Architect's Supplemental Instructions

Architect's ASI No: 064

Project:
Webster University
Interdisciplinary Science
Building

Date Issued: 04/26/17

ID0102

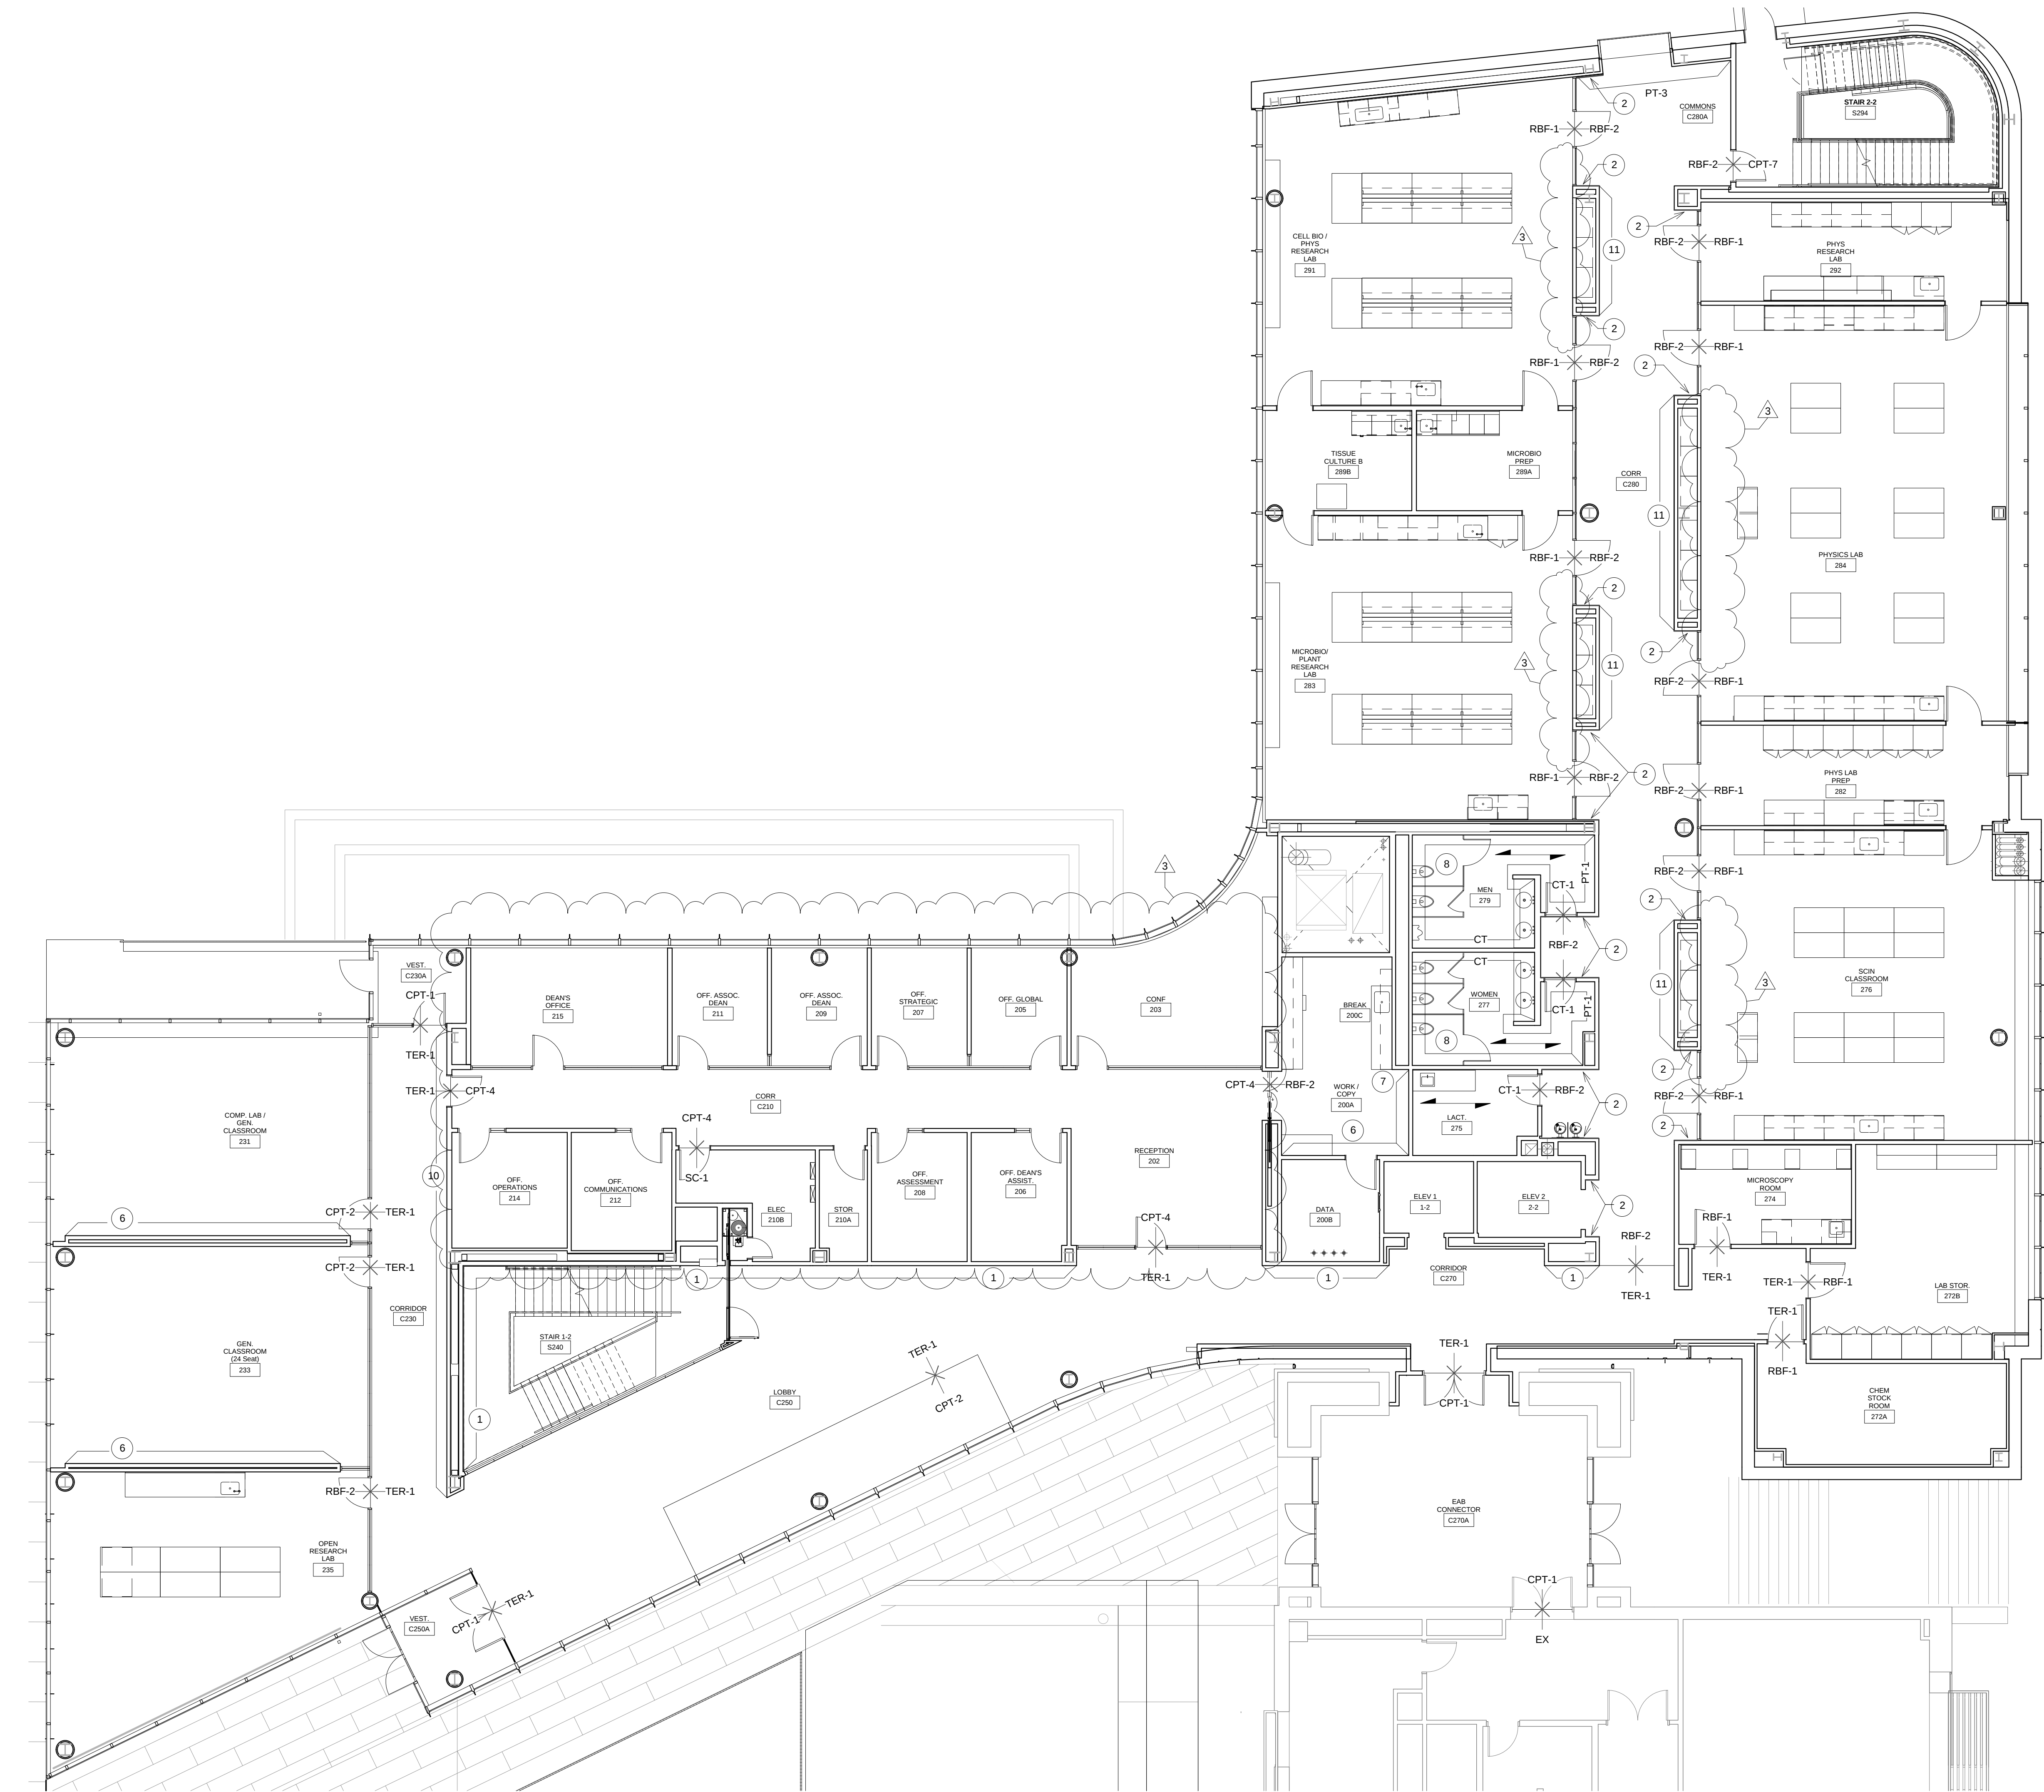
- Keyed note 12 was deleted from every private offices, eliminating dry erase paint from the offices.
- Keyed note 6 was removed from the labs which will receive walltalker product per Architectural elevations in lieu of dry erase paint.
- Dry erase paint was added in Conference 154.
- Dry erase paint was added in Commons 303.
- Dry erase paint was eliminated from Commons C450A.
- Dry erase paint was eliminated in the corridor outside the General Chem Lab 472; per new keyed note 12, this wall will receive cork wall treatment only.
